**Car Stereo
Service Bulletin**

Model: CDX-A20

No. 135

Subject: Improvement Of Signal To
Noise Ratio

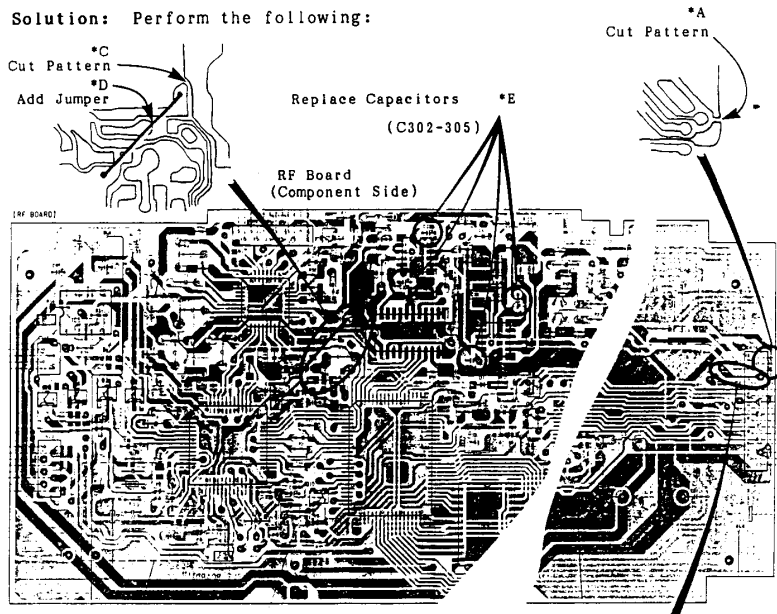
Symptom:
(54)

When between tracks (no sound) or quiet passages, servo noise may be heard.

Solution: Perform the following:

Ref. No.	Description		Part Number
	Former	New	
C302-305	100/6.3V	1/50V	1-121-912-00
